# Service Technical Information

MODEL NO. CSD-MD30 / MD50 / MD70 XR-MD100 / MD101 / MD200 / MD201 / H220MD
SUBJECT Precautions on Repairing MD Mechanisms

REF.No. :G - A0 - 036 - E1

Revision : SUBJECT change, model addition, MD mechanism suffix addition, and the addition of information

Fig-1 AZG-4 mechanism

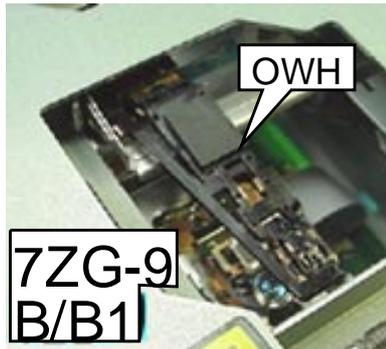
The above models contain the "7ZG-9 B/B1" and "AZG-4 A" MD mechanism.  
Before repairing your product, confirm the type of MD mechanism is used in the product.

1. If your product contains the 7ZG-9 B/B1 mechanism, refer to the relevant Service Manual For the AZG-4 A mechanism, refer to Service Manual (09-001-341-2N2). Since the MD test mode is the same as that of the 7ZG-9, refer to the Service Manual corresponding to the model of your product. (The MD test mode described in the Service Manual of the AZG-4 A MD mechanism is for the XR-MD510.)
2. When activating the mechanisms EJECT mode, if the letter "A" can be seen through the hole in the holder shield top, the mechanism is a AZG-4 A. (See Fig-1 below) The "A" mark signifies the suffix assigned to AZG-4 A, and this mark is not given to the 7ZG-9 Series.

Although MD mechanisms have been changed, the main microcomputers remain unchanged. But, do not interchange the two mechanisms when loading because those two mechanisms are not compatible.

Fig-2 OWH of the 7ZG-9 mechanism

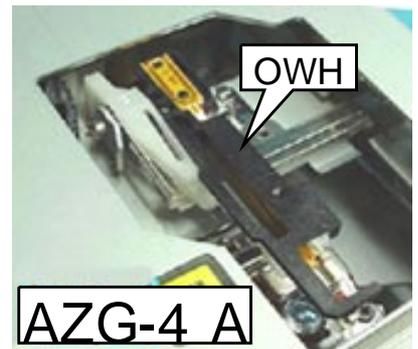
\*The 7ZG-9 B/B1 mechanism uses "RF325-74A" as its OWH. (See Fig-2 below)  
The AZG-4 A mechanism uses "RM-21E" as its OWH. (See Fig-3 below)
